UNITED STATES PATENT AND TRADEMARK OFFICE

APPLICATION NO.	FILING DATE	FIRST NAMED INVENTOR	ATTORNEY DOCKET NO.	CONFIRMATION NO.
10/779,702	02/18/2004	Robert Colin Pugh	P66775US1	8963
136	7590	04/17/2006	EXAMINER	
JACOBSON HOLMAN PLLC 400 SEVENTH STREET N.W. SUITE 600 WASHINGTON, DC 20004			MITCHELL, KATHERINE W	
			ART UNIT	PAPER NUMBER
			3677

Office Action Summary

DETAILED ACTION

Fig. 13

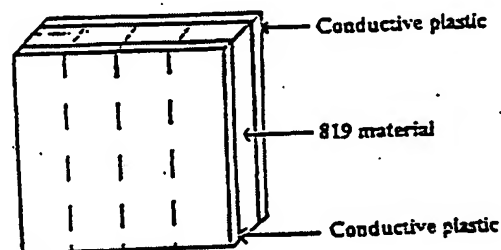
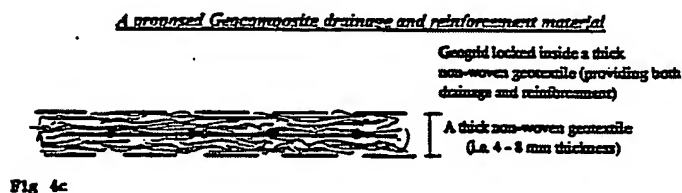
Jones teaches an EKG drain structure comprising a composite geosynthetic liner with enclosed core element surrounded by a sheath, and a conducting element (conductive plastic, Fig 13) for direct contact with substrates of ground materials-- it is the outer layer. The reinforcing core element is 819. Note that Fig 4c shows the proposed structure for the 819 material, and it includes channels and voids. A sheath (conductive plastic) substantially surrounds the core and is in direct contact with the core outer surface, and the sheath is conductive, as described in the

abstract and Figures, and col 5 line 60 - col 7 line 30 (US), pg 10 line 20-page 14, line 15 (PCT). A possible conductive element is taught as metallic polypropylene (col 21, lines 1-3 US, pg 46, lines 8-9 PCT), or the stitched metal filament on the outer surface of the sheath as shown in numerous examples, including Fig 13. The sheath would be porous where the stitches poked through, per Fig 13. The mesh (Fig 4c) inherently forms drainage channels, (see broad definition above):

In the twelfth design a layer of 819 material (150 mm×150 mm) was sandwiched between two layers of conductive plastic sheeting each (150 mm×150 mm). This would comprise the cathodic component and was stitched, once again, with three rows of stainless steel stitching, FIG. 13.

Fig 18

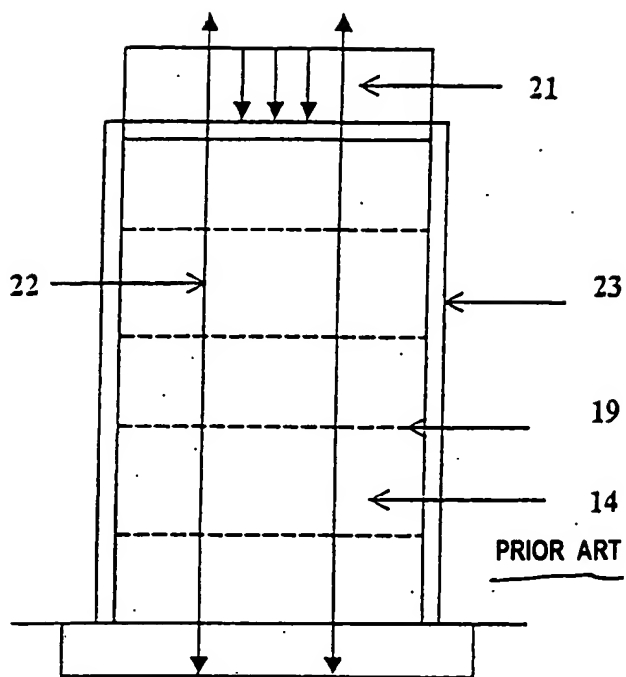
1. Revised Fig 18 is accepted and entered.
2. Applicant's statements that 12-14 are not prior art is accepted. The confusion was due to applicant's use of the description "conventional".
